# CHEM-NUCLEAR SYSTEMS, INC.

REFERENCE: Docket No. 71-9094

We respectfully submit our response (Attachment 1) to the questions raised in your June 24, 1985 letter concerning Model CNS 14-195-H shipping package.

Responses to NRC Request For Information dated June 24, 1985, Docket No. 71-9094.

**TRANSPORT CASK ASSEMBLY - PLAN**

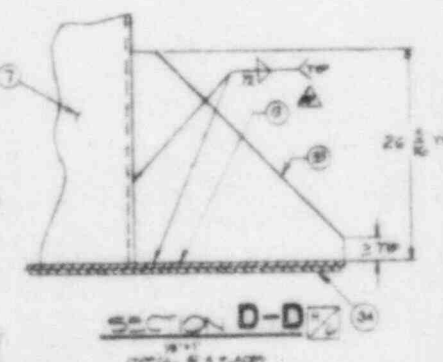
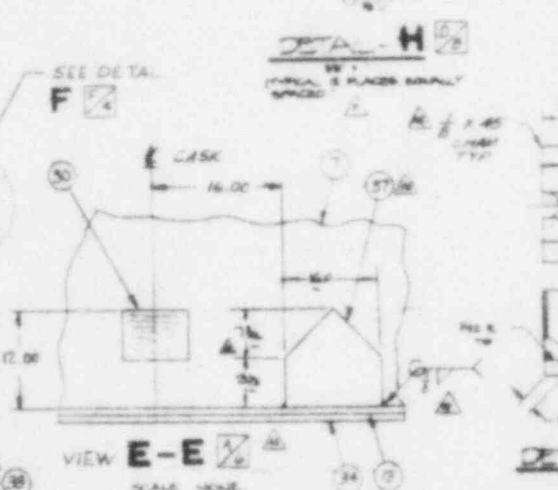
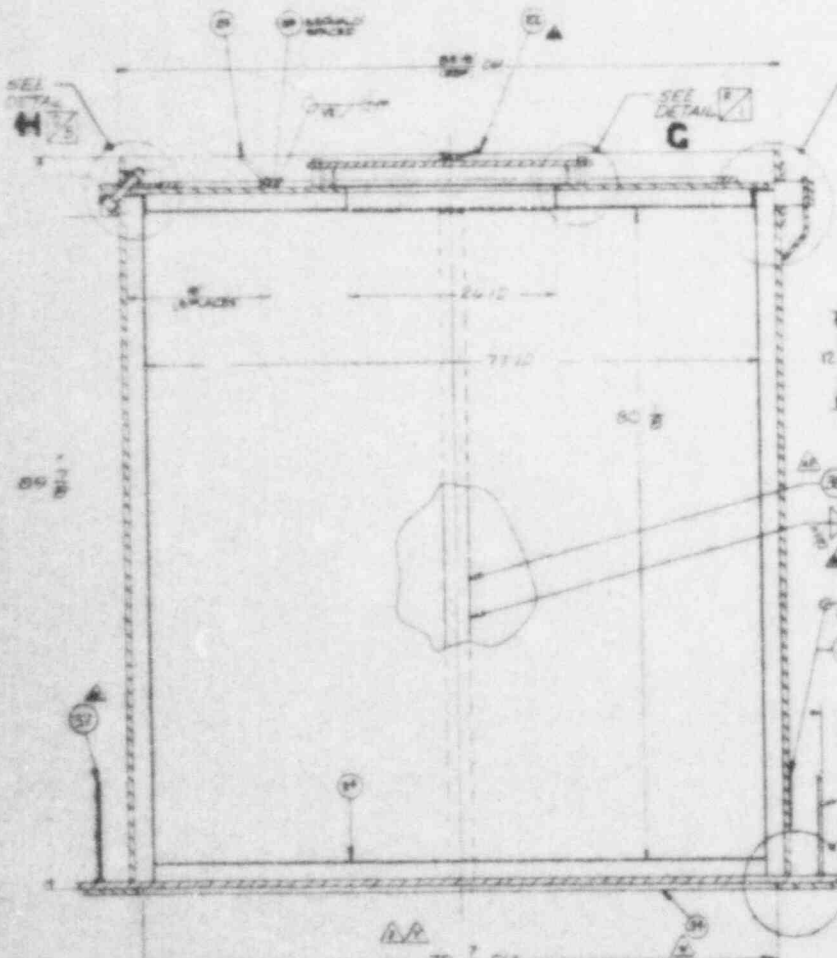
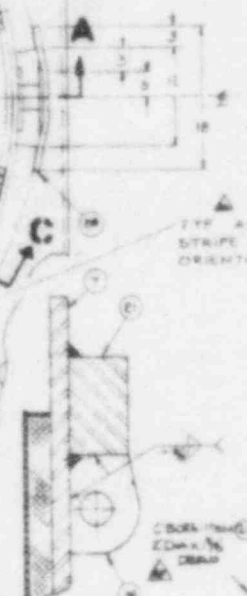
| NRC Comment   | C.2  | Step 8 under 7.2 Loading Procedures for Liners requires the use of alignment marks to correctly position the secondary lid onto the primary lid. The packaging drawing should be revised to show the required alignment marks. It is noted that Section 8.0, Tests and Maintenance, also discusses lid alignment marks. |

| CNSI Response | A.2  | Revision AG has been issued to CNSI Drawing 1-189-101 which shows the alignment marks. The reference to this drawing throughout the Safety Analysis Report has been changed to identify the current drawing revision.   |
